Glendale Dam, NDI ID Number 912.
Susquehanna Basin, Beaver Dam Run,

Cambria County, Pennsylvania.
Phase I Inspection Report.

PHASE I REPORT
NATIONAL DAM INSPECTION PROGRAM

PHASE I
NATIONAL DAM INSPECTION PROGRAM
GLENDALE DAM
NDI I.D. NO. 912
DER I.D. NO. 11-101

GLENDALE DAM NDI: 912
GENERAL PLAN
FIELD INSPECTION NOTES
FIELD INSPECTION DATE: AUGUST 9, 1978

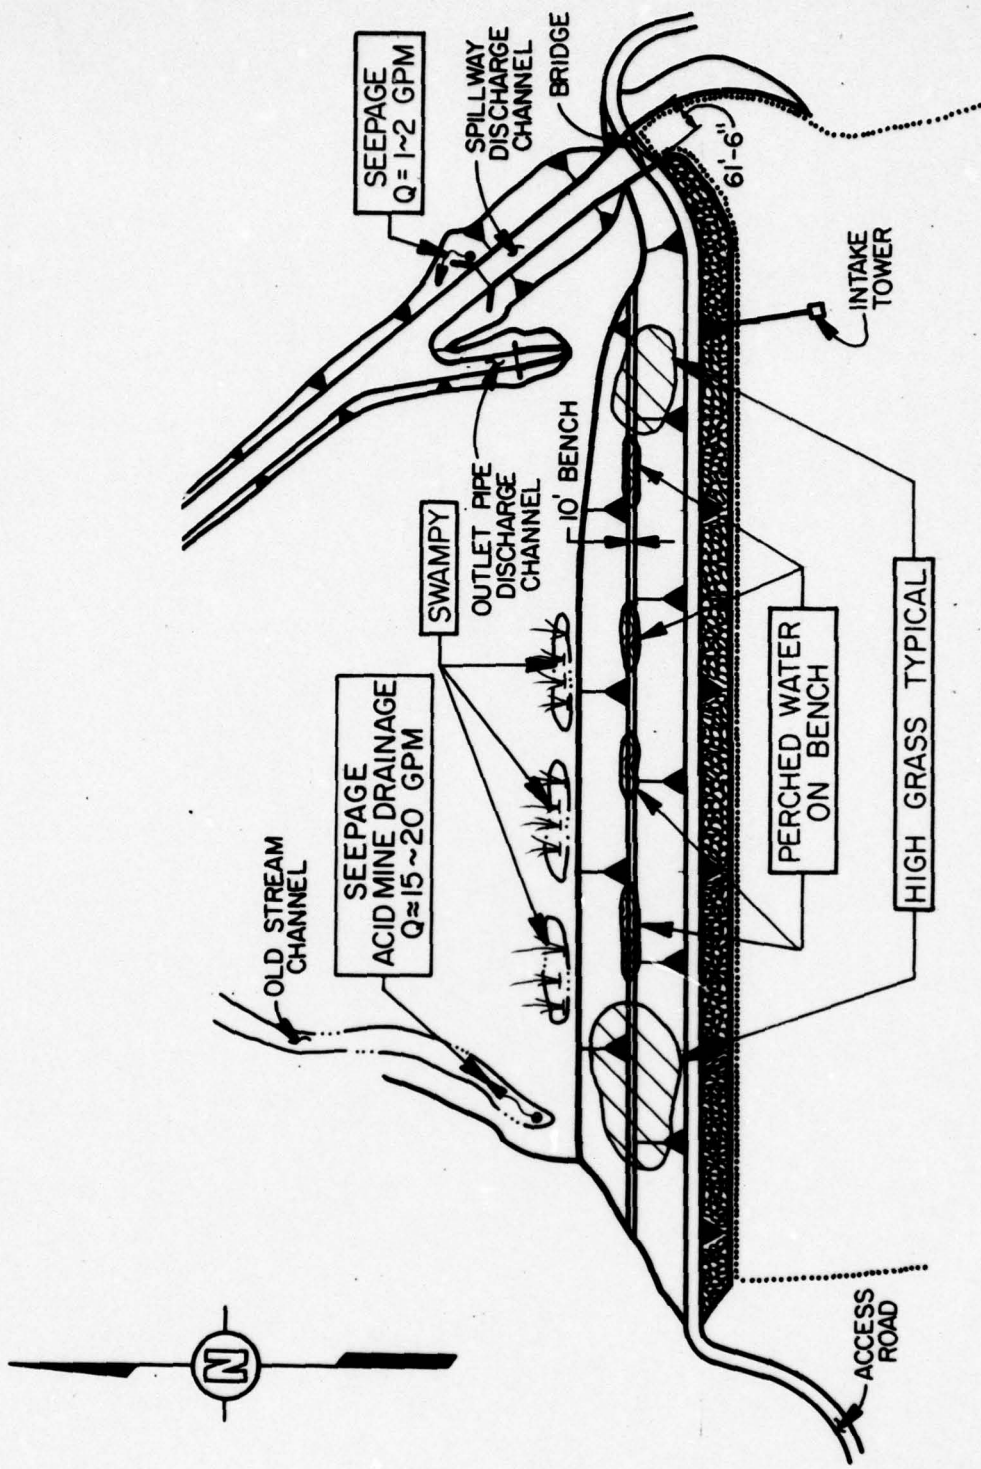
The specific observations are illustrated in Plate 13 and in the photographs in Appendix C.

In general, the condition of the dam is considered to be good. Only one significant seepage area was found. This seepage was located at the junction of the embankment and the left abutment at the toe level of the dam. The seepage contained acid mine drainage and the flow was estimated to be in the range of 15 to 20 gallons per minute (gpm). Swampy areas were located along the toe of the dam. However, no flow was observed from these areas. A minor seepage was located on the right side of the spillway plunge pool, flowing approximately one to two gpm. Also, no indication of flow was observed from the perched water on the downstream slope bench.

Photograph No. 8
Acid mine drainage (left abutment at toe level).

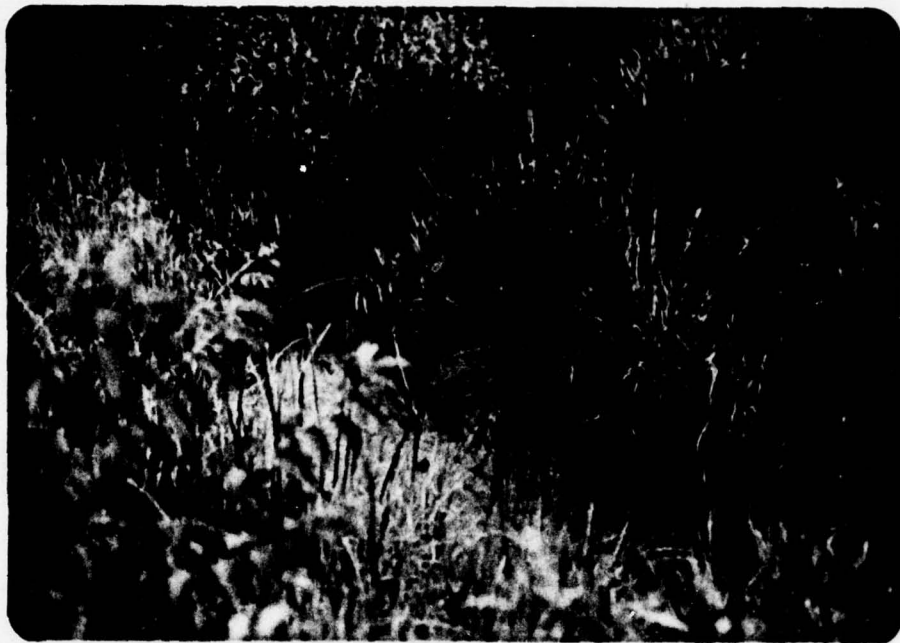
3.2 Evaluation. The condition of the dam is considered to be good. The outlet pipe was half full due to the backwater from the stream. Therefore, the outlet pipe was not inspected. The acid mine drainage observed at the junction of the embankment and the left abutment at toe level is not considered to affect the overall performance of the dam at this time. However, this seepage should be monitored and recorded to determine that the flow is not increasing with time. The turbidity of the seepage should also be observed.

1. It is recommended that the quantity and turbidity of seepage on the left abutment should be monitored and recorded. If conditions degrade, a detailed study should be made and necessary remedial measures taken.
2. High grass on the embankment and the toe area should be mowed at least annually to facilitate future inspections.
3. It is recommended that the owner provide around-the-clock surveillance during unusually heavy runoff and develop a formal warning system to alert the downstream residents in the event of an emergency.
